Delegated officer report for planning application

Application no. 135875/LP/2023

Proposal: Enlargement of dwellinghouse comprising of Part A - Erection of a single storey rear extension, Part B enlargement of roof to install a rear dormer and Part C installation of 2no. front roof lights

Address: 3 Lytham Avenue, Manchester, M21 8TF

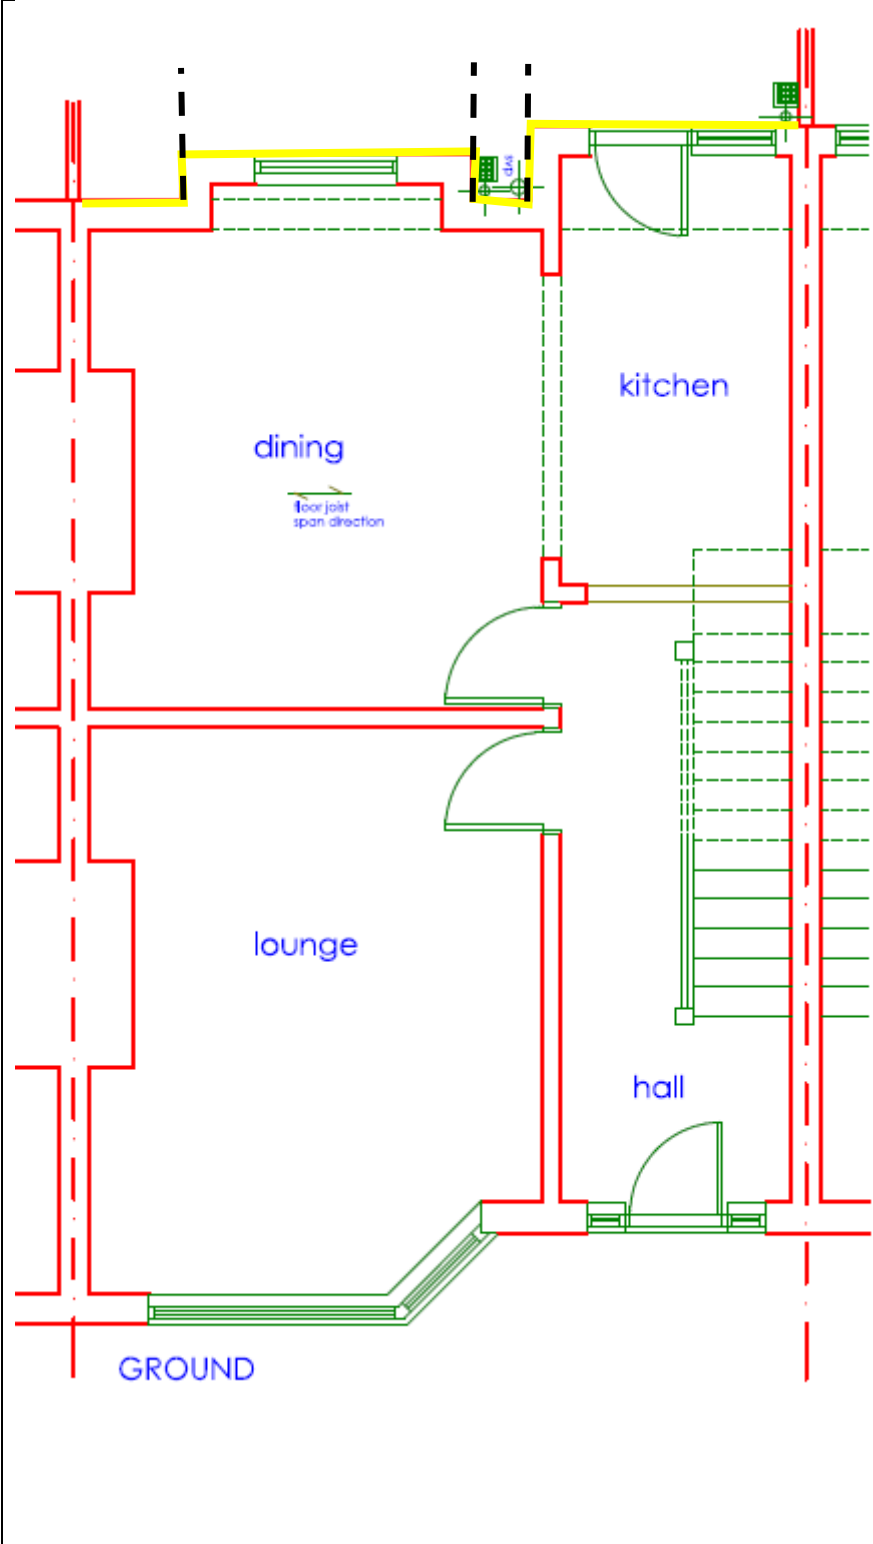
(iii) have a width greater than half the width of the original dwellinghouse; or	No
Explanation As shown in the image below (image 1) the yellow line indicate the position of the original rear wall, and the dotted black line indicates the side walls. Whilst the outrigger and bay would be demolished or modified as part of the proposal, the development would consequently, extend beyond a wall forming a side elevation of the original dwelling. Therefore, as proposal would form an extension beyond the side wall (indicated as a dotted black line in image 2) joining both and result in a width of 3.63 metres for the extension and therefore greater width than half the width of the dwellinghouse and does not comply with A.1 (j)(iii) of the GPDO.

Refuse on the basis that the proposed single storey rear extension, as detailed on the submitted DWG 01 and 02 does not constitute permitted development, as it fails to accord with Part 1, Schedule 2, Class A.1(j)(iii) of the Town and Country (General Permitted Development) Order 2015 (as amended), as the enlarged part of the dwellinghouse would extend beyond a wall forming a side elevation of the original dwellinghouse, and would have a width greater than half the width of the original dwellinghouse.
